Access Compliance Report

Public Rights-of-Way

(Pedestrian Signals)

Intersection ID: N/A	Main Street:	Cross Street: N/A	Location: N/A
ADA ID: D93BAEA4AEF7	Signal Type: One Push Button-APS	Overall Compliance: No	Severity Score: BTN 1: N/A BTN 2: N/A No BTN: N/A
Codes/Mitigation Info/Possible Solution		Field Measurements/Component Compliance

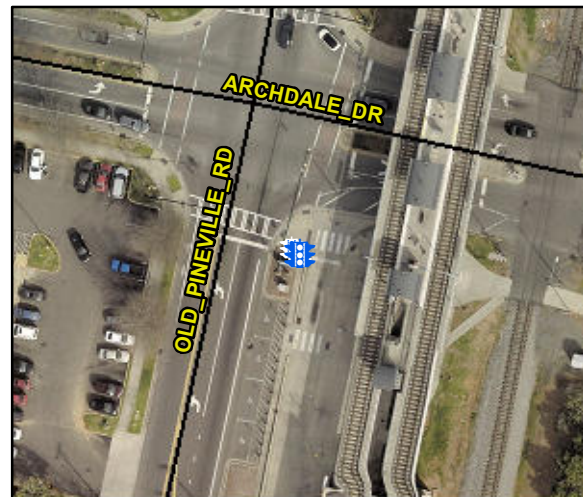
Surveyor Notes: 3 BUTTONS ON ONE POLE

PROW/ADA: , TMUTCD 4e.08, R404.3, R404.7.1, R404.7.2

No B 1 Clear Xing Direction?	NotClearlyMarked	N/A B 2 Clear Xing Direction?	N/A
B 1 Crossing Direction	To E	B 2 Crossing Direction	N/A
Yes B 1 DistanceTo XWalk (in)	8.0	N/A B 2 DistanceTo XWalk (in)	N/A
No B 1 DistanceTo Curb (in)	123.0	N/A B 2 DistanceTo Curb (in)	N/A
Yes B 1 Diameter (in)	2.0	N/A B 2 Diameter (in)	N/A

Possible Solutions: Replace Signal Push Button With APS Button on New Post. Remove & Relocate Sign.
